Friday, May 5, 2023

Lillian Kuri, Commission Chair

May 5, 2023

EC2022-010 – UCI Development | Stokes West New Construction REVISED:

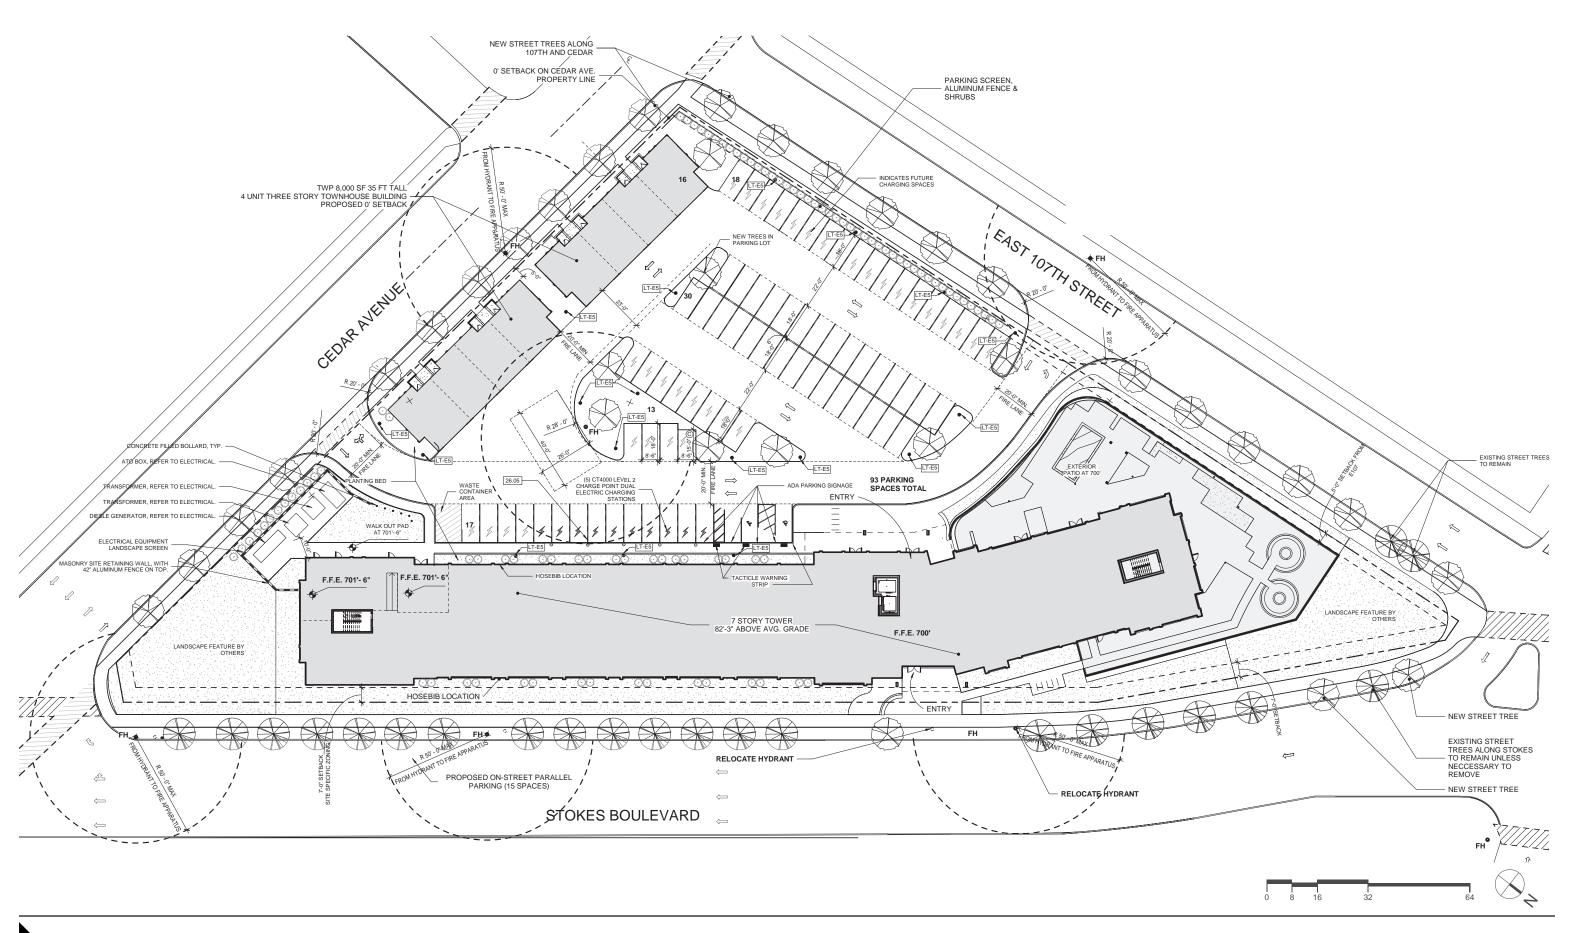
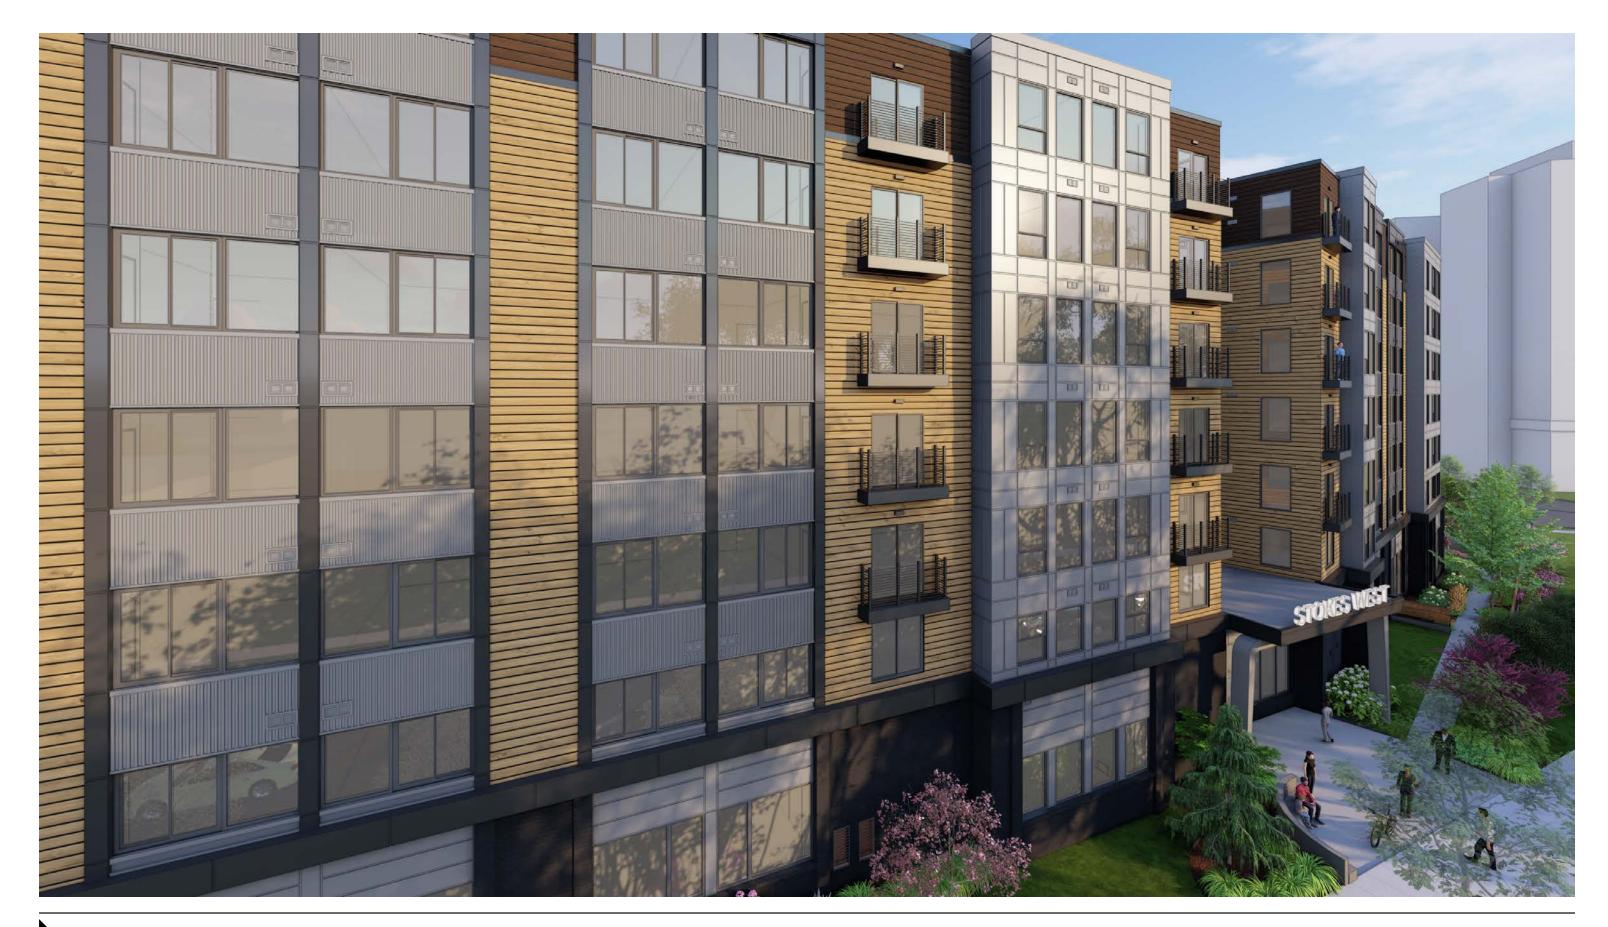
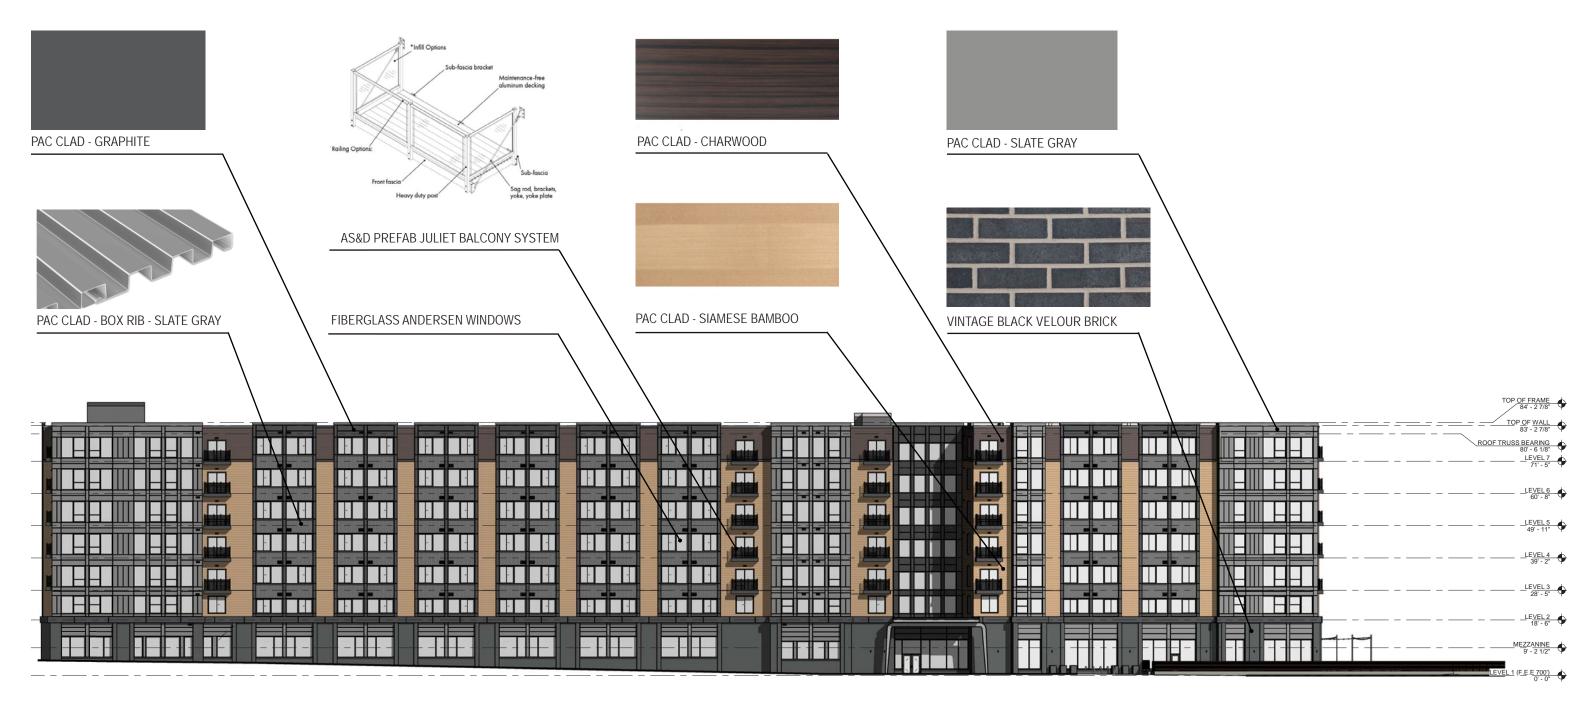
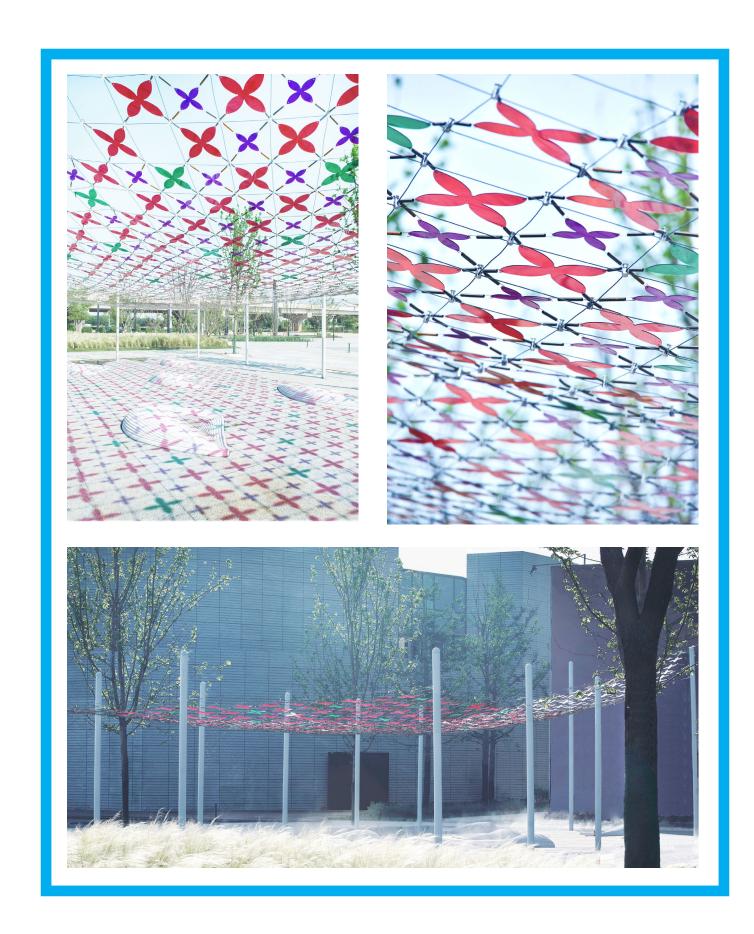
- 1- Clarify function of new space between the two townhome buildings in landscape plan updates.
- 2- Add some treatment on the wall, just right of entry door on building rear, to add visual interest.
- 3- Main building seems like a large & monolithic structure, and a significant departure from previous iteration.

- 8- Insure proper screening of electrical equipment near the corner of Stokes & Cedar.
- 9- Return with complete lighting plan.
- 10- Material on building ends appearnot to enhance the quality of the building.
